# ORIGINATION FORM

Proposed Revisions to a Standard Plans Index  
(Please provide all information – Incomplete forms will be returned)

Index Number: 440-002  
Sheet Number (s): 1 of 1  
Index Title: Underdrain Inspection Box

Reorganized Index into multiple sheets. Updated Notes language.

**SHEET 1 of 3**

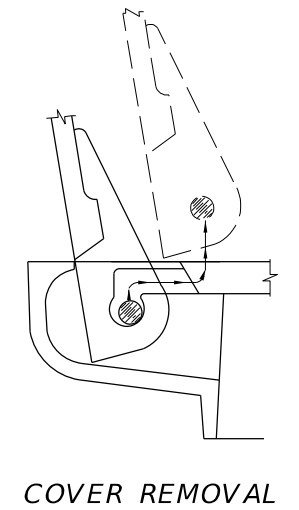
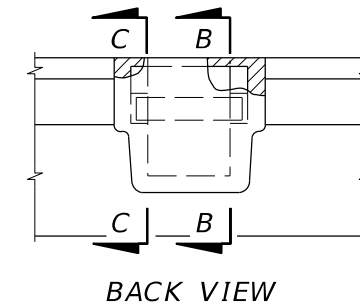
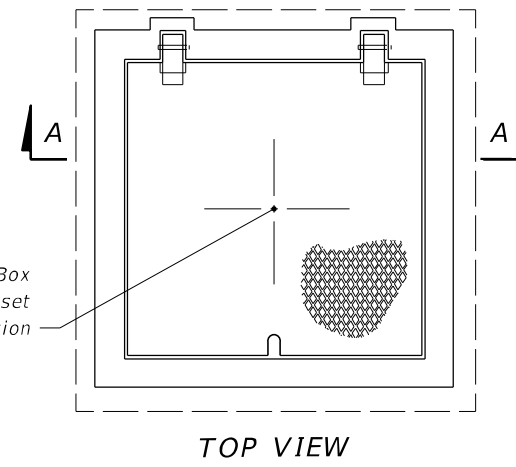
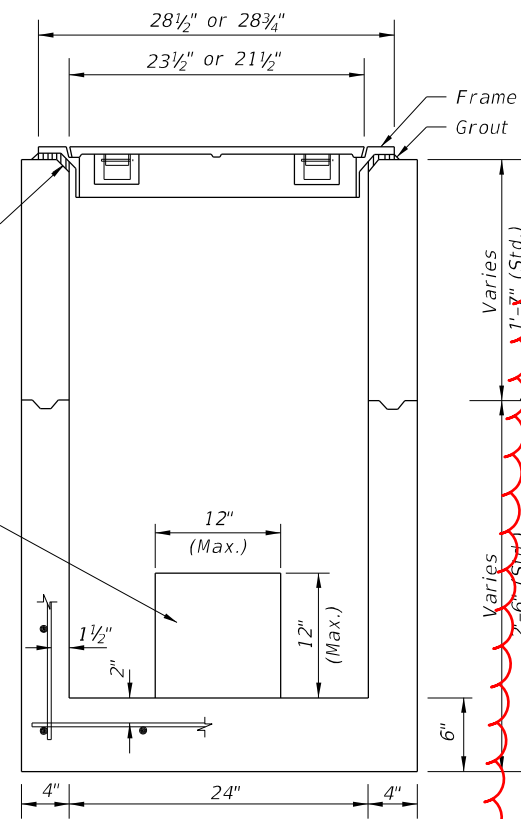
NEW SHEET 1 OF 3

**MOVED TO SHEET 3**

**MOVED TO SHEET 2**

**SHEET 1 UPDATED NOTES**
